Prony Resources New Caledonia

**Prony Resources New Caledonia
Tailings Storage Facility (TSF) – KO2
Independent Geotechnical Review**

In summary, the scope of work is for an independent peer review to assess the liquefaction risk of the KO2 dam fill materials and foundation soils as well as the stability of the dam under long term seismic loading. Required by the local authorities (DIMENC) according to decree n°692 2021/ARR/DIMENC of March 18, 2021, the peer review must also meet the expectations and concerns of the stakeholders, namely Prony Resources, DIMENC and the local Great South communities.

Figure 11. Comparison between two nearby CPTs:

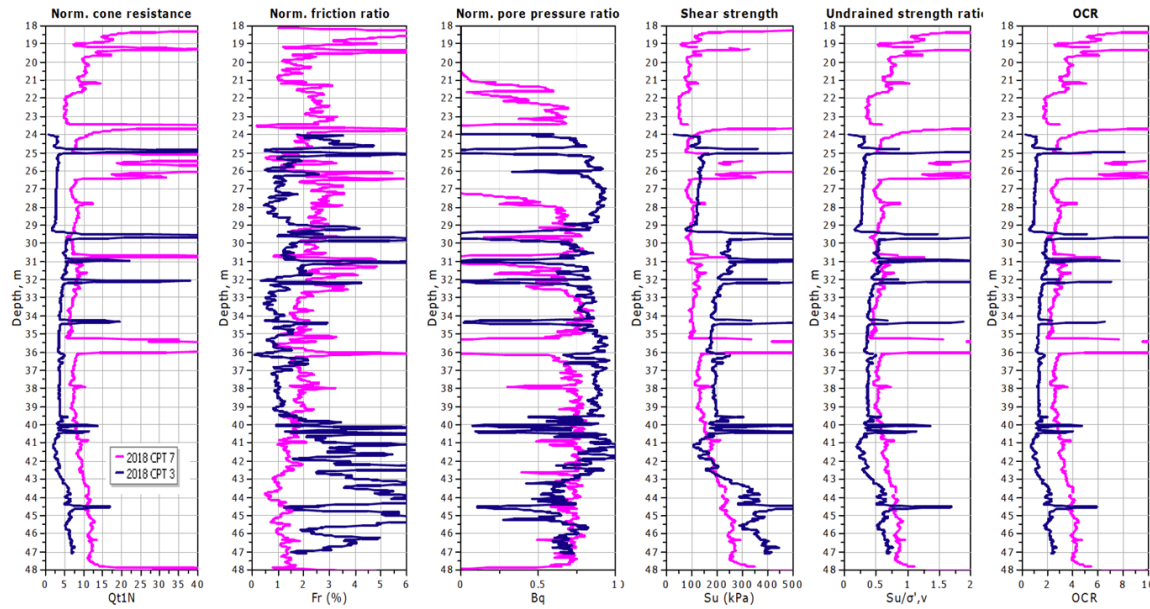
Figure 11 shows how the estimated OCR has changed from values around 3 to 4 at the toe of the dam down to 1.0 below the dam. The estimated peak undrained shear strength ($s_{u(p)}/\sigma'_{vo}$) values also show a slight decrease. The imposed stress from the embankment at these locations is around 400kPa (approximately 20m of fill) and this appears to have exceeded the average yield stress, since the resulting OCR is close to 1.0. This is also consistent with the observed large settlements under the KO2 dam.

Figure 14. Summary of laboratory measured peak undrained shear strength ratio as a function of vertical effective confining stress (Golder, 2020)

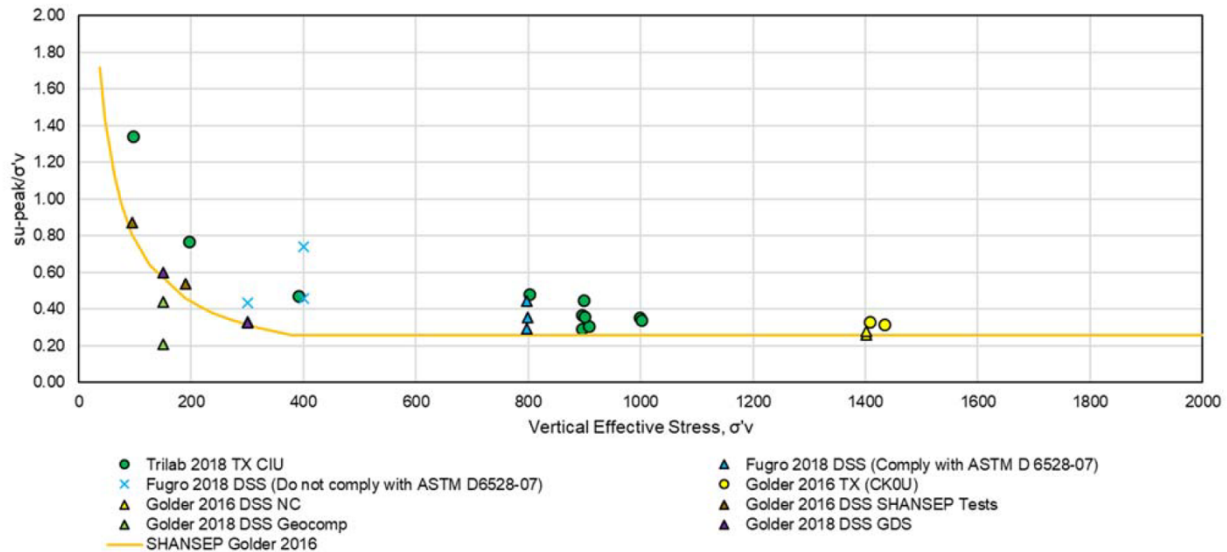
As illustrated by the results in Figure 14, a limitation with laboratory data is that the small amount of test results is often not sufficient to fully quantify the in-situ variability.

The high vertical effective stresses under the KO2 dam make the Limonite behavior more like a normally consolidated clay with resulting low peak undrained strength ratio. This observation is supported by the in-situ test results. The laboratory testing at high stresses shows that the Limonite is also ductile in undrained shear and experiences strength loss (softening) with increasing strain. Most laboratory tests showed continued strength reduction (softening) with increasing strain until the test was stopped at the strain limit of the equipment. The resulting large strain residual undrained strength ratio was often around $s_{u(r)}/\sigma'_{vo} = 0.15$, although final constant residual strength had not been reached (see Figure 15). The observed ductile response of the Limonite tested at higher stresses is consistent with the relative high plasticity of these residual soils. In summary, the Limonite under the KO2 dam can be expected to behavior like a plastic normally consolidated clay with a peak undrained strength ratio ($s_{u(p)}/\sigma'_{vo}$) of around 0.25 and a ductile stress-strain response and post-peak strain softening at large strains.

Figure 16. Idealized section of KO2 dam (CH500, Golder, 2020)

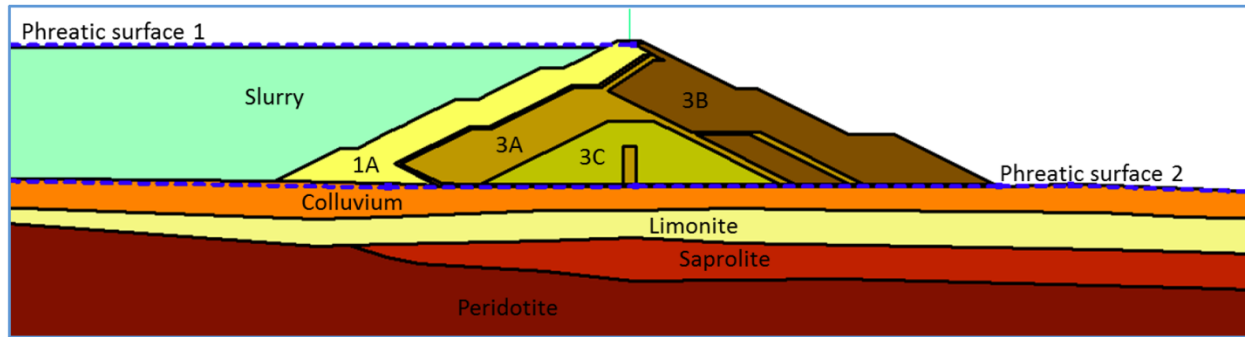
The risk of liquefaction in the fill materials used to build the dam is very low. The available data indicates that the fill material is composed of compacted rock fill and clay-like Limonite. The data indicates that the fill is predominately unsaturated and dilative at large strains. Hence, both cyclic and flow liquefaction is unlikely. The compacted Limonite fill in the downstream slope of the KO2 dam can be expected to behave in a drained manner, consistent with the design assumptions.

The compacted fill used to construct the KO2 dam has a very low probability of liquefaction, as described above.

Figure 17. Summary of static stability analyses under undrained conditions performed by Golder (2018) using (a) Limit Equilibrium and (b) FLAC.

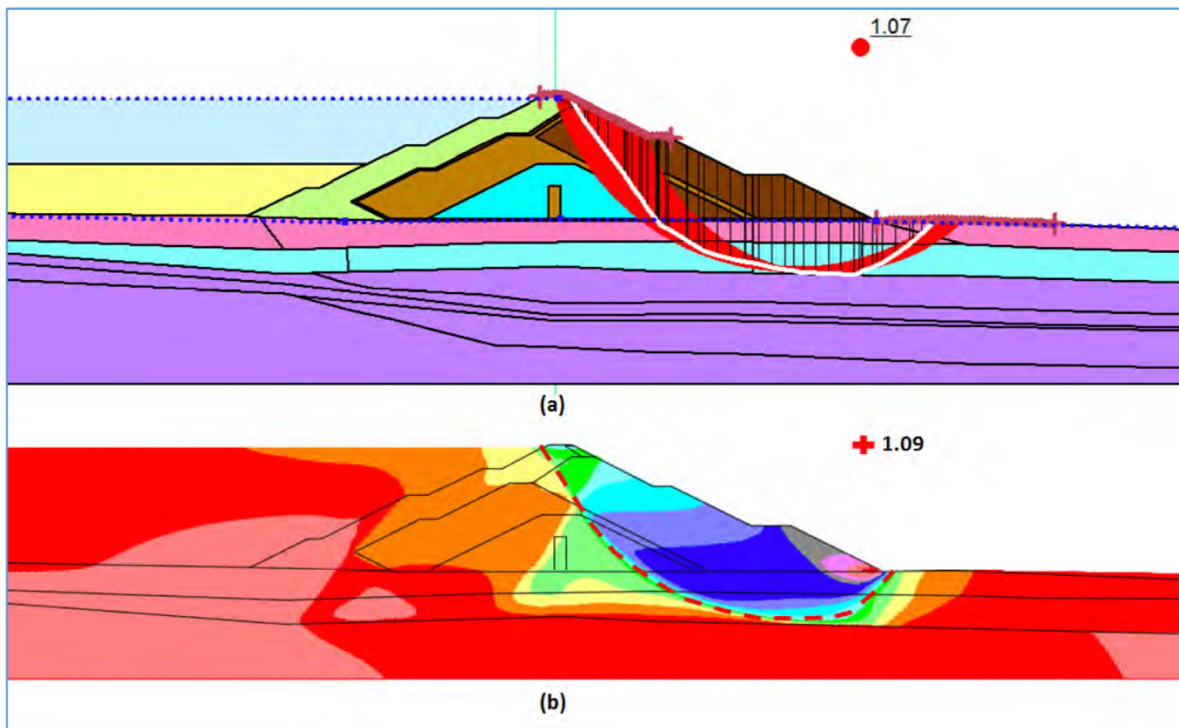
The calculated factor of safety values for the KO2 dam are below ANCOLD recommended minimum values and Golder had recommended further study to be done in 2021 that included: additional laboratory testing, additional site investigation to include geophysical testing to determine the Vs values in the fill and underlying residual soils and to analysis additional dam cross sections. A review of the preliminary results from the 2021 investigation indicate that the 2021 results are consistent with the 2018 results and confirm that the in-situ residual soils retain some bonding from the parent rock. The residual bonding tends to make the soils stiff and relatively strong at small strains but contractive at large strains as the bonding becomes destroyed resulting in a weaker shear strength under undrained conditions. High overburden stresses can also destroy the beneficial effects of the residual bonding. The strength of the residual bonding is variable resulting in variable behavior characteristics with a high level of uncertainty.

The Golder (2018) analyses assumed that no strain softening would occur in the softer residual soils below the dam. If strain softening does occur, the resulting deformations will be larger, but it is currently not possible to estimate if these deformations would be acceptable.

The main issue is whether undrained conditions will initiate any strain softening resulting in possible large deformations. The regions with conditions most likely to experience any strength reduction are the regions where saturated, contractive residual soils exist under high static shear stresses, i.e., under the downstream slope of the KO2 dam, as illustrated in Figure 17.

Since the KO2 dam does not currently meet ANCOLD standards for static undrained conditions, it is assumed that some form of the Lucy Project will be carried out to ensure that the dam will meet these standards. Since the primary driver for undrained conditions is earthquake loading, which is probabilistic in nature, the schedule to improve the response of the dam to earthquake loading should also be based on probabilities which would require a quantitative risk assessment.
